NUMBER: 25-002-14

GROUP: Emissions Control

SUBJECT:

Malfunction Indicator Lamp Illumination Due To Oxygen Sensor

Fig. 1 FOUR WIRES FROM TRUCK MUST BE TRANSFERED TO OVERLAY HARNESS

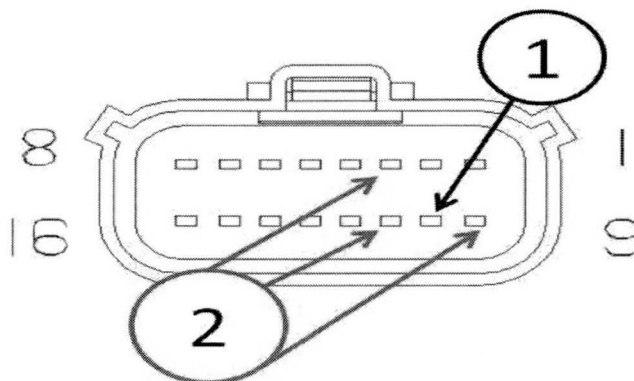
NOTE: In the following steps, four of the terminals will be removed from the original Oxygen Sensor Module connector and installed in the 68250763AA overlay harness Oxygen Sensor Module connector. Of those four terminals, some MY11 trucks were built with tin terminals and should have been gold plating. Three of the four terminals, (if required, determined below) will need to be replaced with the gold plated terminals supplied in the 68250763AA kit.

11. Disconnect the original **Oxygen Sensor Module Connector** and remove the protective tape and plastic shield on the connector.
12. Carefully cut the tape securing the convolute tubing to the wiring near the new Oxygen Sensor Module connector and pull convolute tubing off wire bundle about 8" (203 MM) from connector.
13. The four terminals that need to be removed from the original vehicle O2 Sensor Module connector and installed in the overlay O2 Sensor Module connector are terminals 3, 9, 10 and 11 as shown in (Fig. 1). Terminal 10 will always be gold plated. Terminals 3, 9 and 11 will need to be inspected on MY 2011 vehicles for plating to determine if new terminals are required.

1 - Terminal 10 - Always a Gold Plated Terminal

2 - Terminals 3, 9 and 11- Must be Inspected on Model Year 2011 For Gold Plating

Fig. 4 TERMINAL 10 IS A GOLD TERMINAL

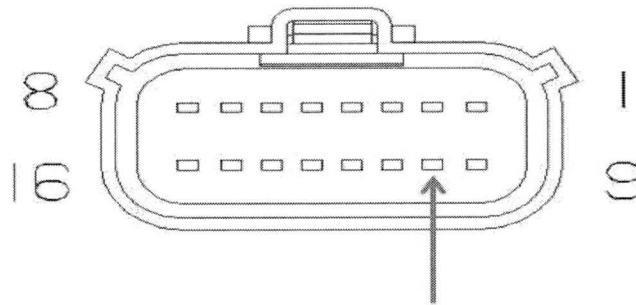
NOTE: Terminal #10 is ALWAYS gold plated and is not required to be changed ON ANY APPLICATION. Inspect terminal #10 to see what the gold terminals look like for a reference when inspecting terminals #3, 9 & 11 in the following steps.

15. Starting with terminal #10 (Fig. 4), push the wire into the connector from the back, and while keeping the tool or drill at 90° angle to the face of the TPA, push the tool or drill in until it releases the lock finger in the connector as shown in (Fig. 5). At this point the wire should pull out the back. As the terminal is removed; note the orientation of the terminal in the connector for ease of installation later.
